UN Regulation No. 131

Uniform provisions concerning the approval of motor vehicles with regard to the Advanced Emergency Braking System (AEBS) for M₂, M₃, N₂ and N₃ vehicles^[EP1]

Figure 2:
Right turn or left turn of a forward vehicle

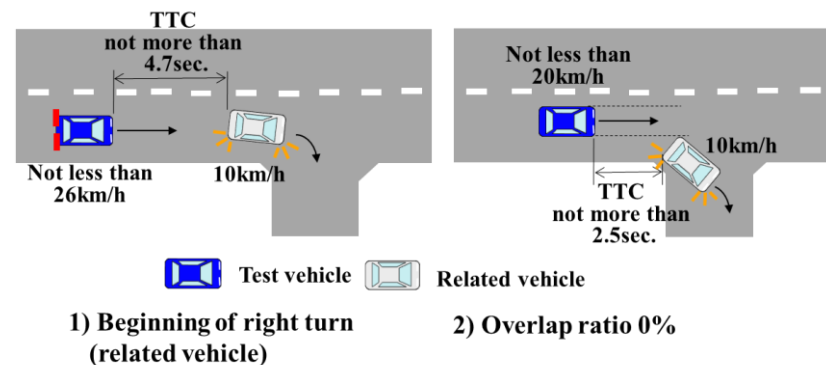
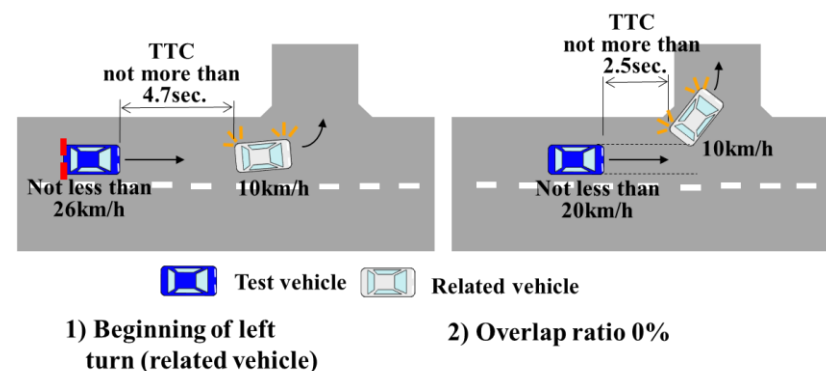
The blue car needs to be changed from passenger vehicle to large vehicle.

Figure 4:
Lane change due to road construction

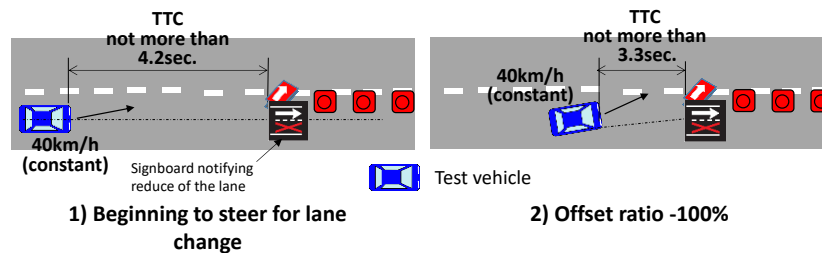
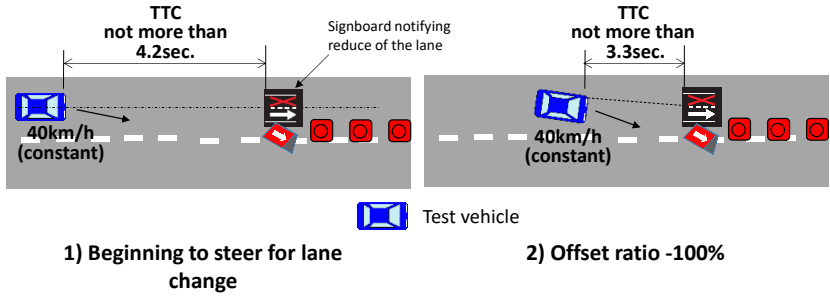
The blue car needs to be changed from passenger vehicle to large vehicle.
